## Sewer Repair and Water Valve Installation Program

### RFB ADDENDUM NO. 04

Date of Addendum: October 1, 2020

**INSTALLATION DETAIL FOR TAPPING LINED RIGID PIPE USING INSERTA TEE FATBOY®**

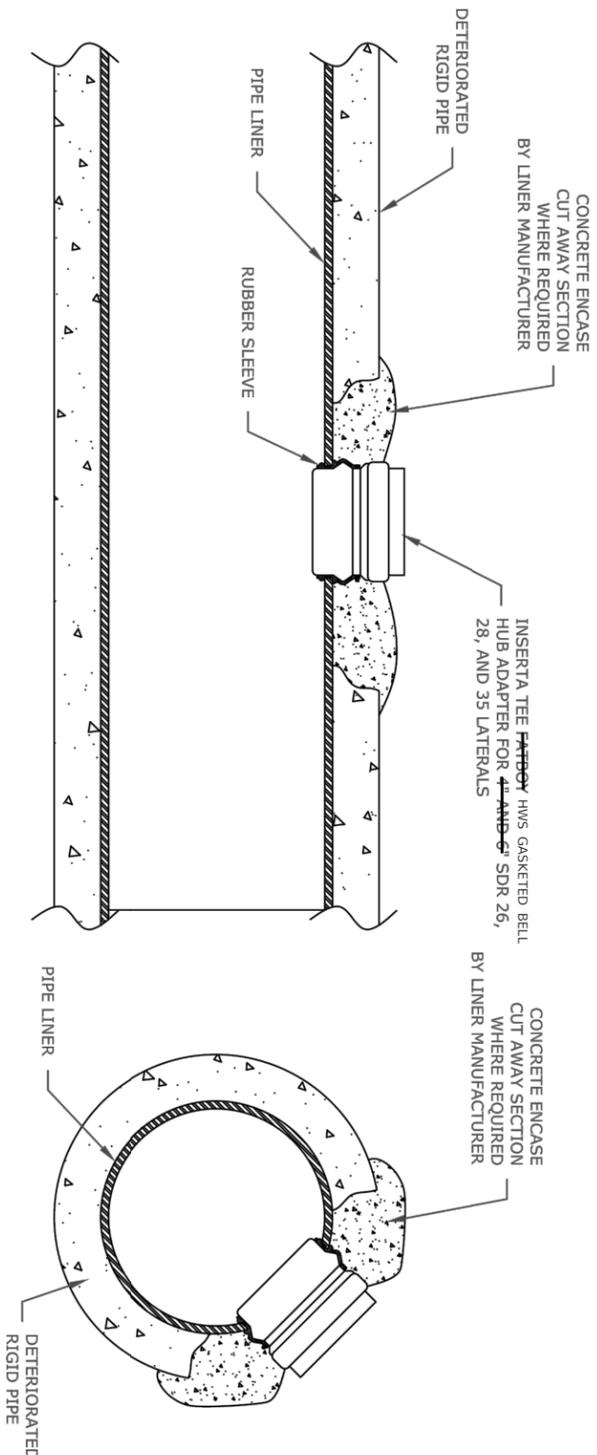
2.2	RFB – Base Bid Sheet & Alternate Bid Sheets	<p>REPLACE – Pages 09-11 of Addendum 02 with the attached page 09-11.</p> <p>CHANGE – LMT Line Main Taps were replaced with Inserta Tee. <b>The Inserta Tee will replace the LMT Saddles for both the 18" and 24" sewer mains on Central Ave.</b></p>

2.3	Attachment Four Special Provisions	<p>REPLACE – Attachment Four in its entirety with the attached Attachment Four.</p> <p>CHANGE – The LMT Lined Main Tap special provisions on page 54.16 of the attached were deleted and replaced with the Inserta Tee special provisions on page 54.15.</p>

Item	Questions and Answers
<p><b>3.1</b></p>	<p><u>Question:</u> Per the manufacturer of the saddles for this job, the vendor states that they no longer make the 24" product. This will need to be addressed prior to the bid opening.</p> <p>Also, regarding the cure time for the adhesive.....there is nothing in your spec on this. Per the below they are suggesting the adhesive cure for 24 hours. Does this mean that we cannot backfill the excavation during this cure time? Or can we do the work and backfill like we would normally do? If we have to leave the excavation open for curing, what to do with the open holes in the middle of your road?</p> <p><u>Answer:</u> See items 2.2 through 2.4 above.</p>
<p><b>3.2</b></p>	<p><u>Question:</u> "Unfortunately we are unable to provide pricing for the 24" saddle. When we requested price and lead time from our supplier, they informed us that their engineer would not clear the manufacture of the 24" and will no longer sell the item. At this time we have not been able to source the saddle elsewhere. I apologize but we will not be able to provide the saddle at this time."</p> <p><u>Answer:</u> See items 2.2 through 2.4 above.</p>

- INSTALLATION INSTRUCTIONS:
1. MARK AREA TO BE TAPPED ON SURFACE OF RIGID PIPE. WORKING AREA SHOULD BE 2-INCHES WIDER THAN DIAMETER OF INSERTA TEE.
  2. BREAK AWAY RIGID PIPE SECTION TO BE TAPPED AND EXPOSE NEW LINER SECTION.
  3. BRUSH AND CLEAN PIPE LINER SURFACE AND REMOVE DAMAGED SECTIONS OF RIGID PIPE.
  4. CORE HOLE INTO LINER WITH APPROPRIATE INSERTA TEE HOLE SAW.
  5. INSTALL INSERTA TEE FATBOY® TAP CONNECTION PER PROVIDED INSTALLATION INSTRUCTIONS.
  6. ENCASE CUT OUT SECTION OF RIGID PIPE WITH CONCRETE WHERE REQUIRED BY LINING MANUFACTURER.
